**ADDENDUM 1 – JOB 1**

TO: All prospective bidders on Project SU-IM-8-984(153)156, Job No. 1 scheduled for the November 13, 2020 bid opening.

PROJECT INFORMATION		
<b>Project:</b>	SU-IM-8-984(153)156	<b>PCN:</b> 21564
<b>Location:</b>	Fargo, ND	
<b>Date:</b>	11/03/2020	<b>Lead Designer:</b> Scott Middaugh
<b>Bid Opening Date:</b>	Nov 13, 2020	<b>JOB#:</b> 1 <b>Addendum#:</b> 1

Revised	11/02/20	STATE	PROJECT NO.	SECTION NO.	SHEET NO.
		ND	SU-8-984(153)156	55	6

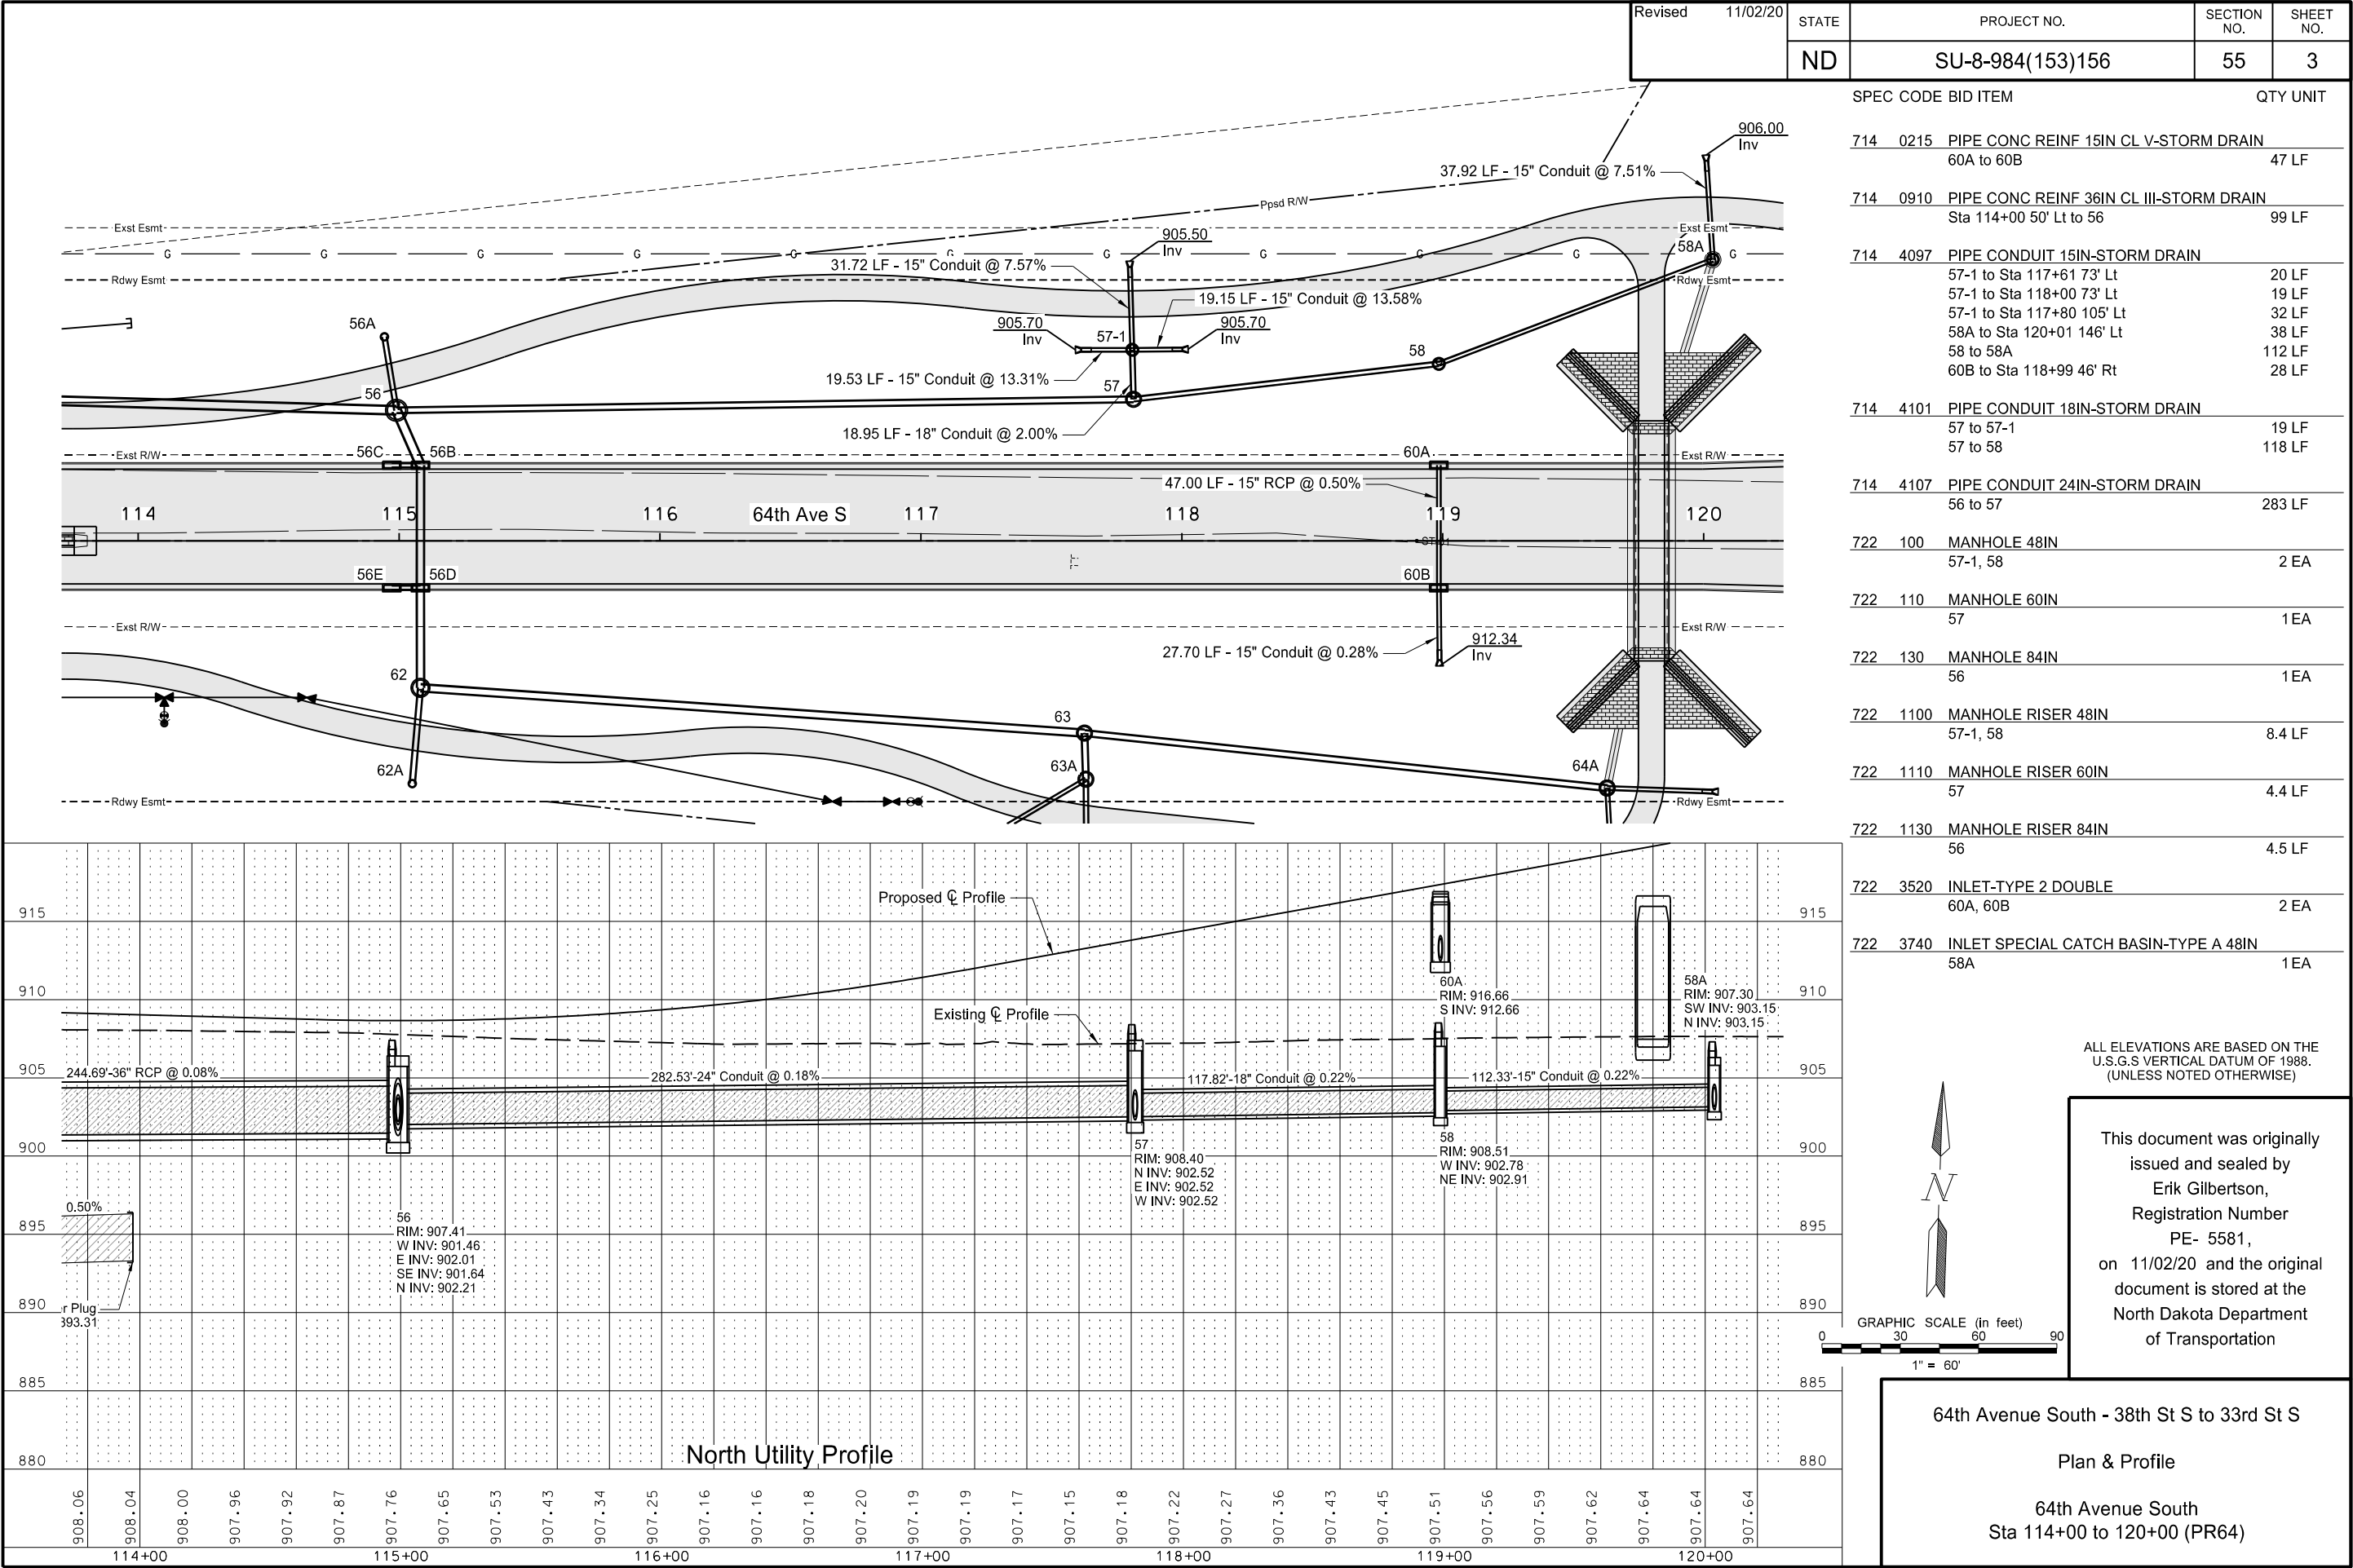
55	5	Removed incorrect property lines on the north side of 64 <sup>th</sup> Avenue.																		
55	6	Removed incorrect property lines on the north side of 64 <sup>th</sup> Avenue.																		
55	10	Removed incorrect property lines on the north side of 64 <sup>th</sup> Avenue.																		
55	11	Removed incorrect property lines on the north side of 64 <sup>th</sup> Avenue.																		
100	1	Revised the following quantities:																		
		<table><tr><td>Spec</td><td>Code</td><td>Description</td><td>Unit</td><td>Previous Quantity</td><td>Addendum 1 Quantity</td></tr><tr><td>704</td><td>0100</td><td>FLAGGING</td><td>MHR</td><td>200</td><td>328</td></tr><tr><td>704</td><td>1000</td><td>TRAFFIC CONTROL SIGNS</td><td>UNIT</td><td>3,417</td><td>3,467</td></tr></table>	Spec	Code	Description	Unit	Previous Quantity	Addendum 1 Quantity	704	0100	FLAGGING	MHR	200	328	704	1000	TRAFFIC CONTROL SIGNS	UNIT	3,417	3,467

Revised	11/02/20	STATE	PROJECT NO.	SECTION NO.	SHEET NO.
		ND	SU-8-984(153)156	110	3

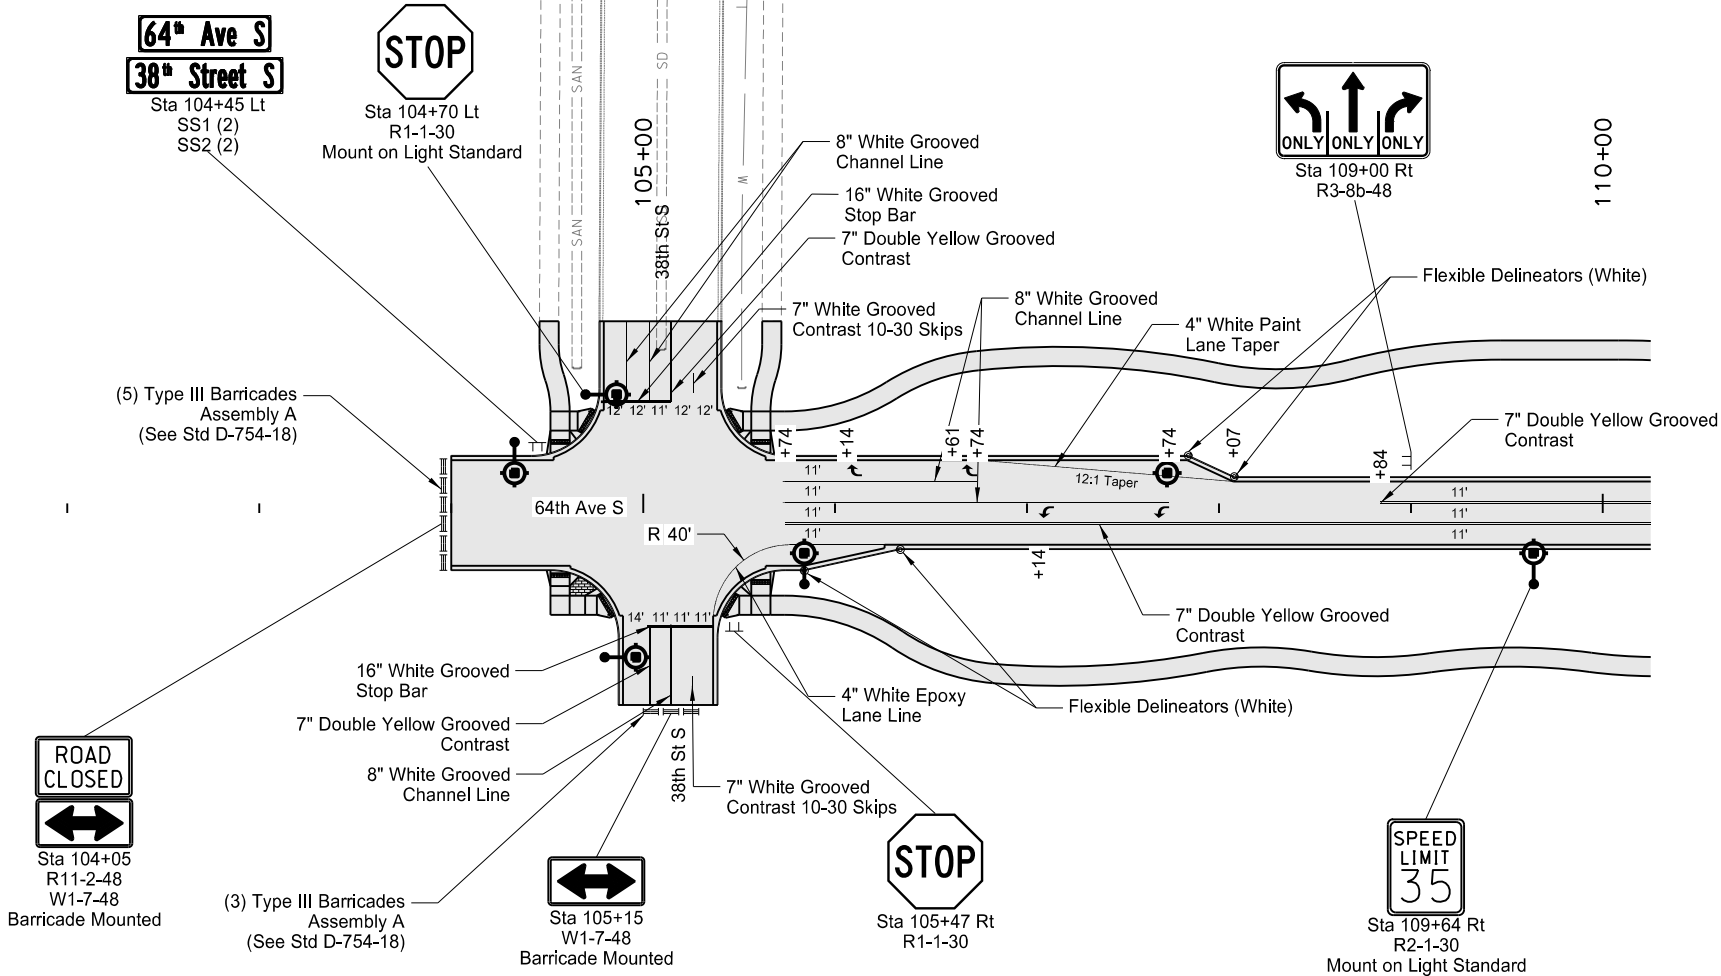
110	1	Revised the quantities for Sign Support Length from 168.8 to 118.2 LF, the quantities for Anchors from 68.0 LF to 48.0 LF, and the quantities for Break-Away from 8 EA to 5 EA.																		
110	3	Revised the location of the sign R1-1-30 to be light pole mounted. Added note about installing signs on light poles.																		
110	4	Revised the location of sign W1-4L-36 to be light pole mounted. Added note about installing signs on light poles.																		
110	5	Revised the location of signs W6-2-36 and W1-4L-36 to be light pole mounted. Added note about installing signs on light poles.																		
110	6	Added note about installing signs on light poles.																		
110	7	Revised the location of sign R2-1-30 to be light pole mounted. Added note about installing signs on light poles.																		
140	1	Revised light offsets and “Lighting Cable & Conduit Schedule” tables.

Revised	11/02/20	STATE	PROJECT NO.	SECTION NO.	SHEET NO.
		ND	SU-8-984(153)156	140	3

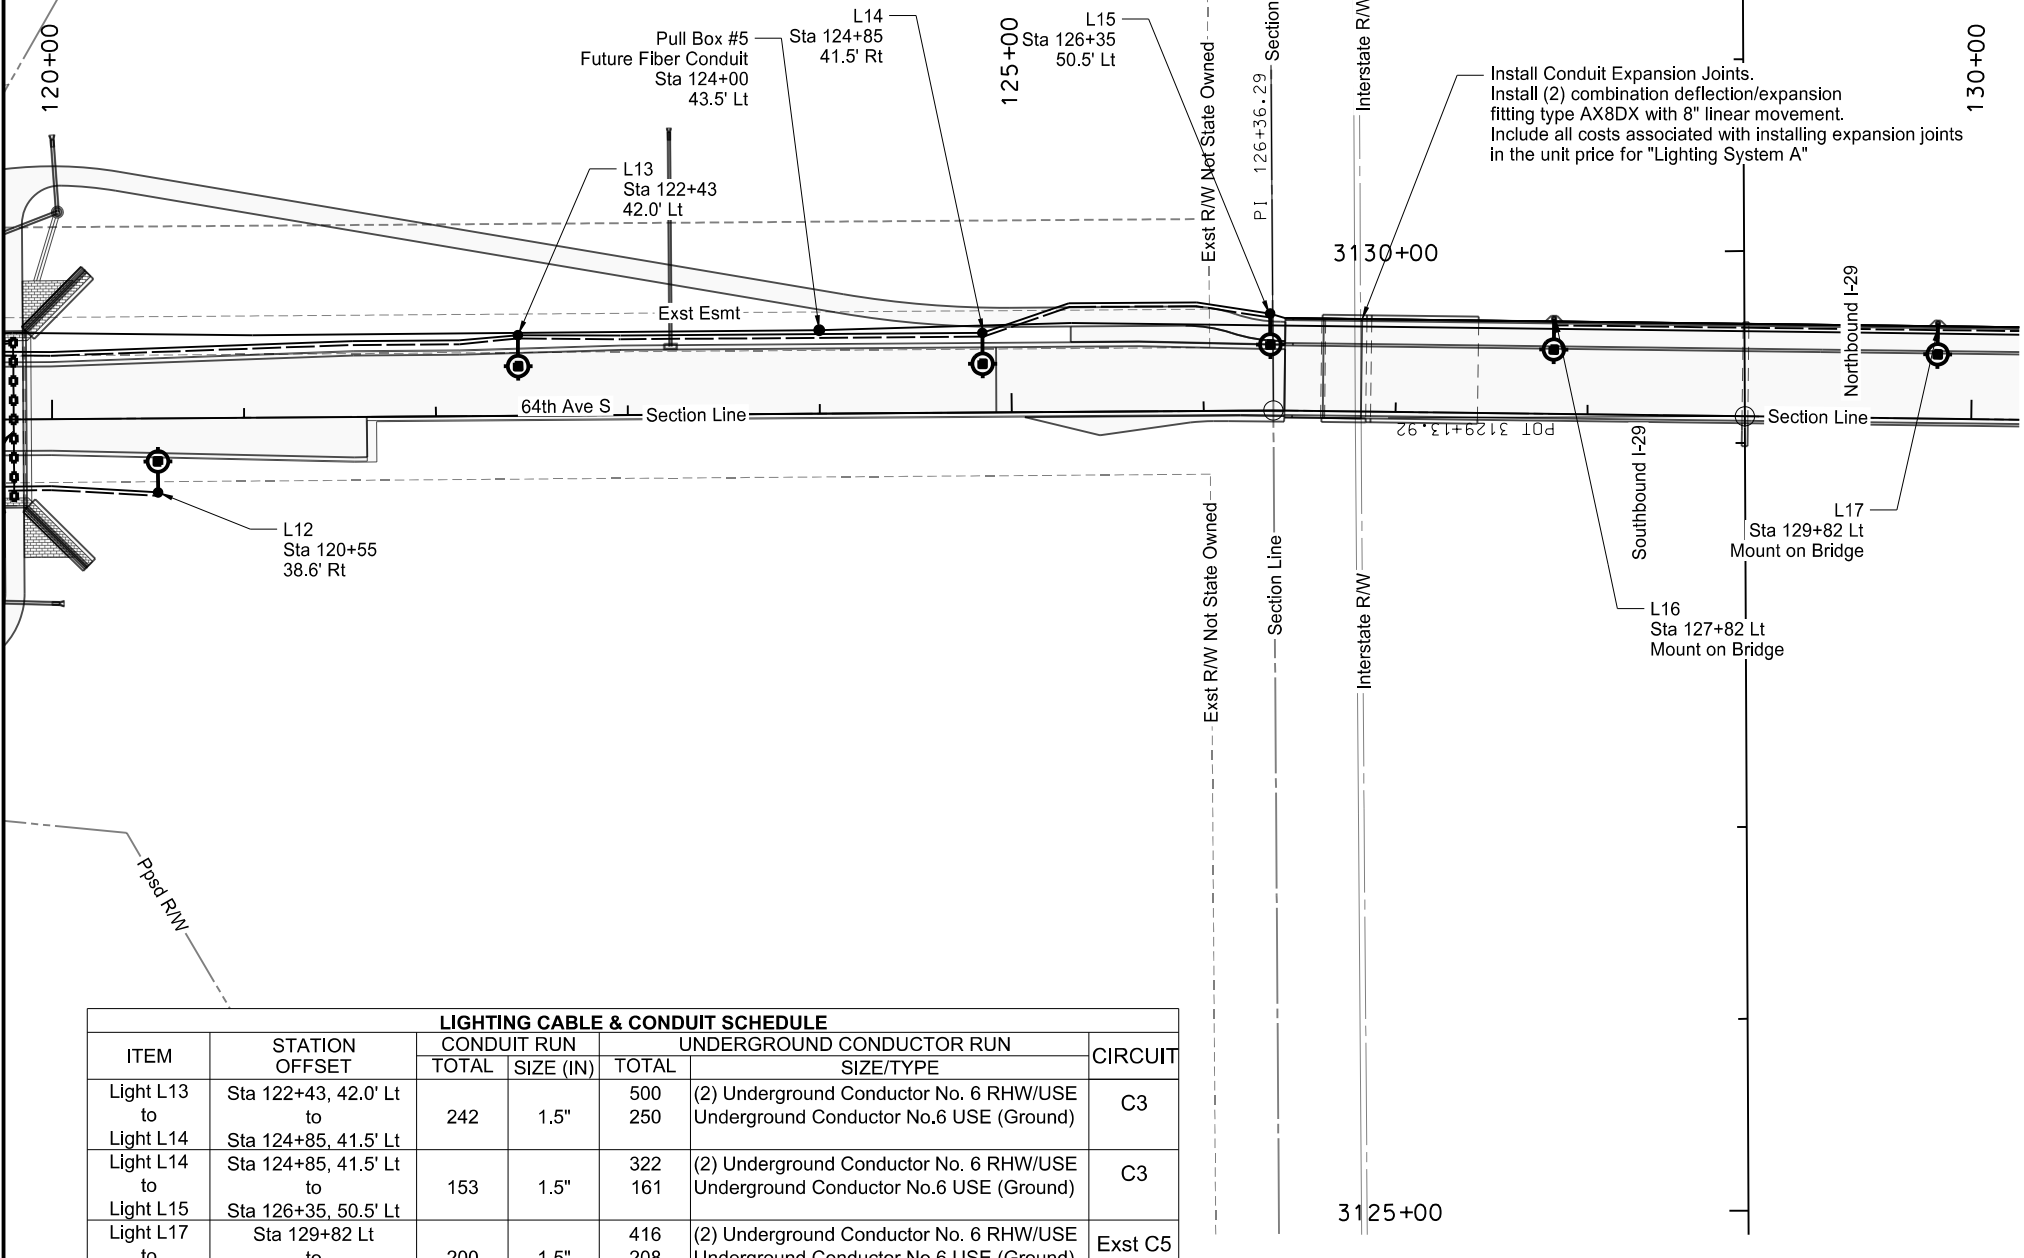
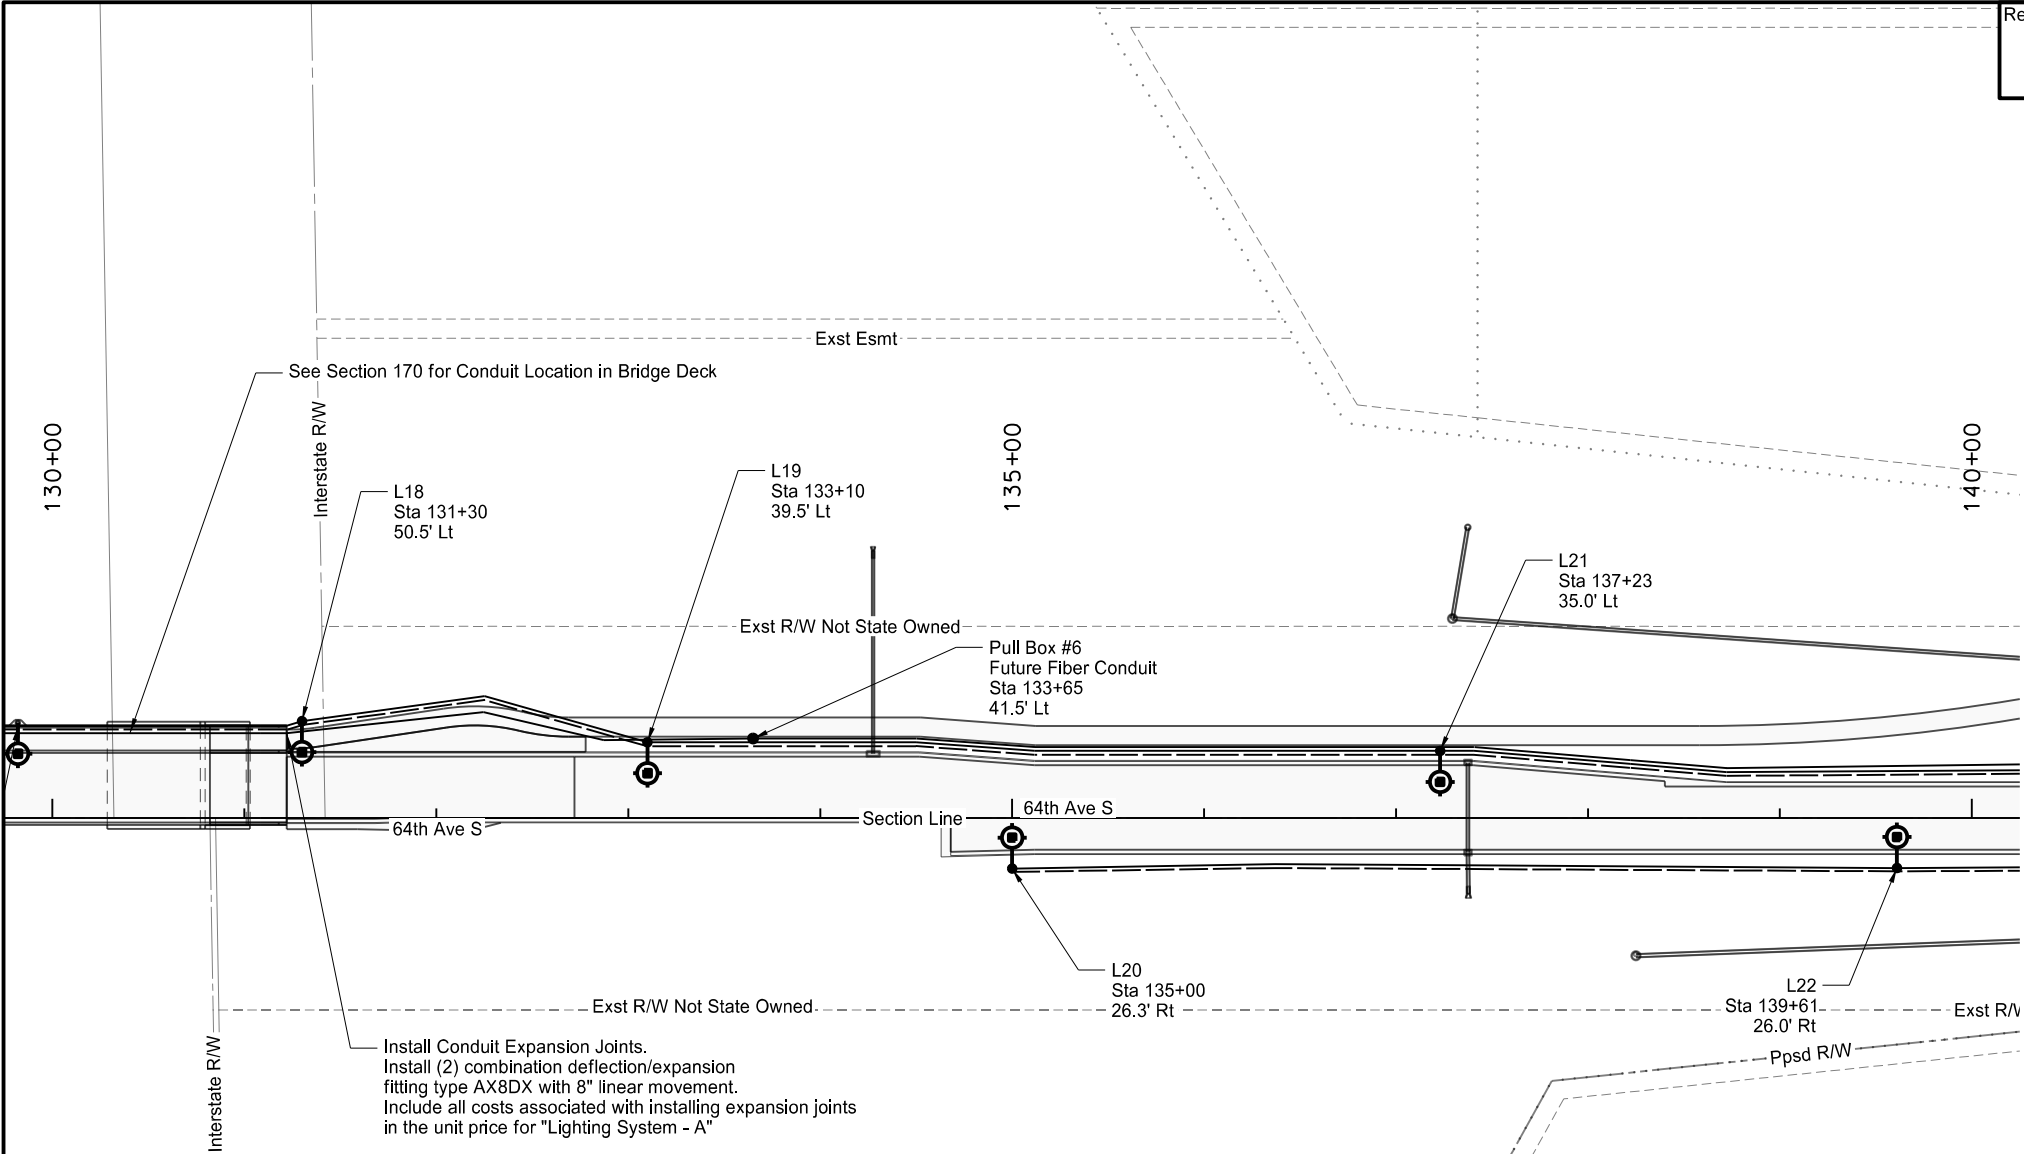
140	2	Revised light offsets and “Lighting Cable & Conduit Schedule” tables.					
140	3	Revised light offsets and “Lighting Cable & Conduit Schedule” tables.					
140	4	Revised light offsets and “Lighting Cable & Conduit Schedule” tables.					
140	5	Revised light offsets and “Lighting Cable & Conduit Schedule” tables.					
140	10	Revised detail name to “Light Standard: With Leveling Nuts”. Revised quantities for Lighting System in the basis table.					
170	1	Abutment 1 North and South Wings were reversed.					
170	2	Note 602 Temporary Bracing was retitled to 616 Falsework and revised. Revised Note 616 Paint and Painting. Color changed to Brown. Revised Note 622 Pile Sleeves. Added statement clarifying what bid item the pile sleeves were paid for under					
170	4	<ul style="list-style-type: none"><li>Revised the following quantities:</li></ul>					
		Spec	Code	Description	Unit	Previous Quantity	Addendum 1 Quantity
